# **RENESAS TECHNICAL UPDATE**

Product Category	MPU/MCU	Document No.	TN-SY*-A0044A/E	Rev.	1.00	
Title	Errata for User's Manual regarding the IIC	Information Category	Technical Notification			
Applicable Product	Renesas Synergy™ S3A1 MCU Group	Lot No. All	Reference Document	S3A1 Microcontroller Group User's Manual Rev.1.20

The specified Renesas Synergy S3A1 User's Manual has incorrect statements about the IIC.

# Page 898 of 1619

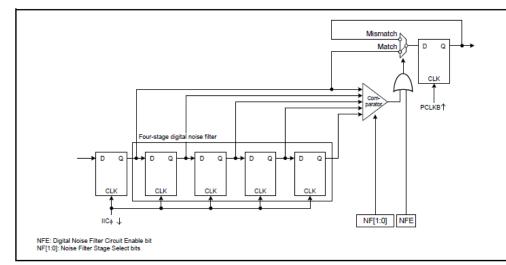
# Incorrect

The IIC can also set the AL flag to indicate the detection of arbitration loss during NACK transmission in master mode or during data transmission in slave mode.

# Correct

The IIC can also set the AL flag to indicate the detection of arbitration loss during NACK transmission in master mode or during data transmission in slave mode.

### Page 925 of 1619

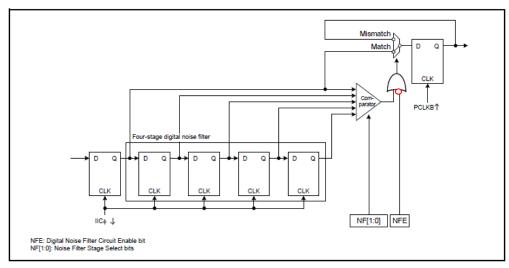
# Incorrect Figure

#### **Correct Figure**

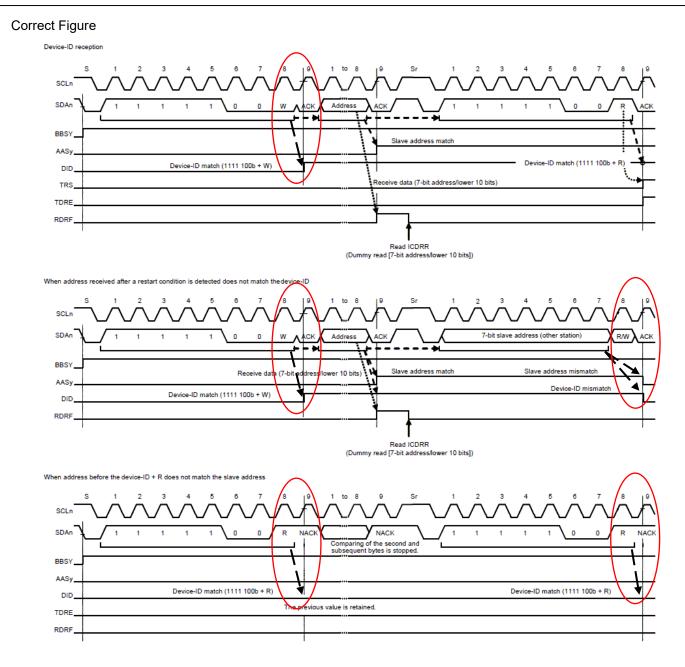
#### Page 941 of 1619 Incorrect Figure (7-bit address + W) [Slave transmit mode] Automatic low-hold (to prevent wrong transmission) Bus free time (ICBRL) 5 2 3 4 6 7 Data (DATA 1) 7-bit slave address w Transfer su ended .... BBSY Address match AASy .... Transmit data (DATA 1) Transmit data (DATA 2) TRS TDRE NACKE Write data to ICDRT Write data to ICDRT Write 1 to SP bit Clear NACKF flag register (DATA 1) register (DATA 2) **Correct Figure** [Slave transmit mode] utomatic low-hold (to prevent wrong transmission) Bus free time (ICBRL) 2 3 4 2 3 4 5 6 5 6 8 7-bit slave address W ACK Data (DATA 1) .... Transfer sus pended BBSY .... Address match .... AASy Transmit data (DATA 1) Transmit data (DATA 2) TRS TDRE NACKE Write 1 to SP bit Write data to ICDRT Write data to ICDRT Clear NACKF flag register (DATA 1) register (DATA 2)

# Page 951 of 1619

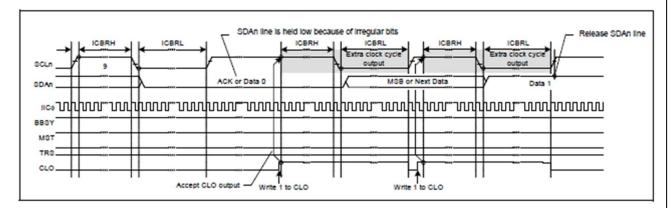
#### Incorrect

Use this function with the MALE bit in the ICFER register set to 0 (master arbitration-lost detection disabled). If the MALE bit is set to 1 (enabled), arbitration is lost when the value of the ICCR1.SDAO bit does not match the state of the SDAn line.

#### Correct

Use this function with the MALE bit in the ICFER register set to 0 (master arbitration lost detection disabled). If the MALE bit is set to 1 (enabled), arbitration is lost when the value of the ICCR1.SDAO bit does not match the state of the SDAn line.

# Page 951 of 1619

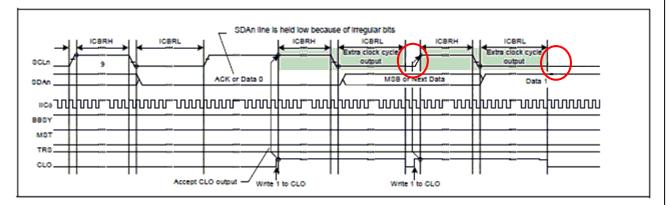
# Incorrect Figure

# **Correct Figure**
